ES_N32WB03x Series Errata Sheet V1.0

1 Errata Sheet

Table 1-1 Errata Overview

7.1 Configuration of ADC clock

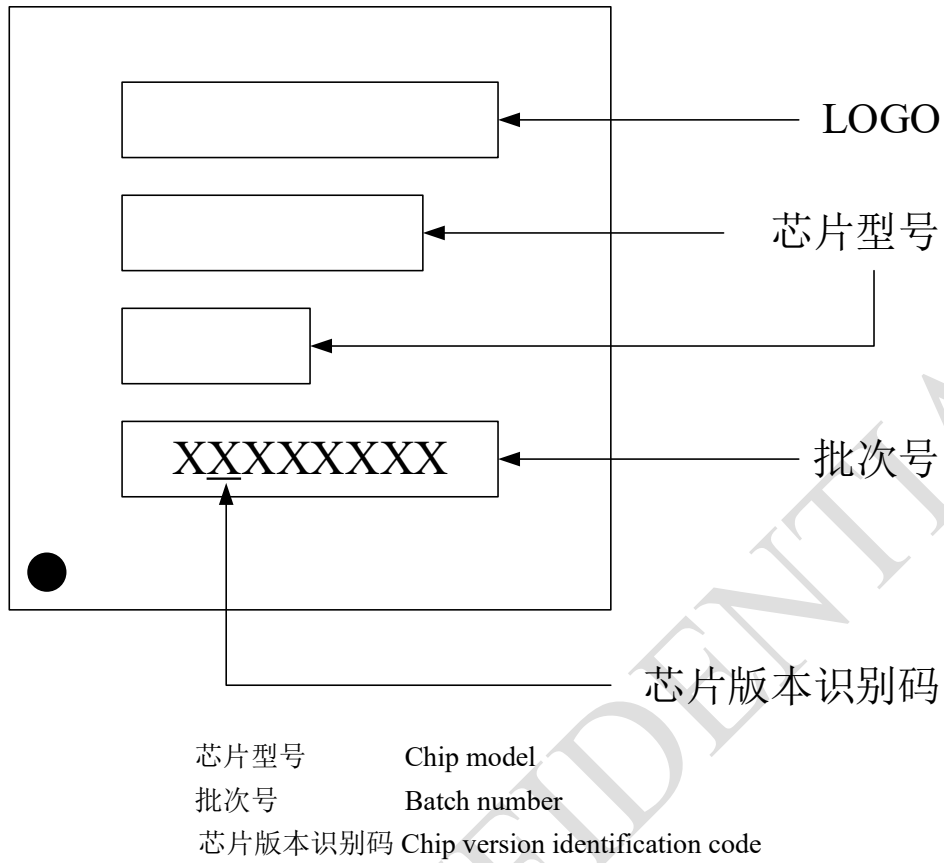
The ADC clock is HSE , if the hardware board without 32M HSE crystal and without BLE function, the ADC will be sampling anomaly .

Configure the HSI as ADC clock, configuration: `*(uint32_t*)0x40011004 |= 0x40`.
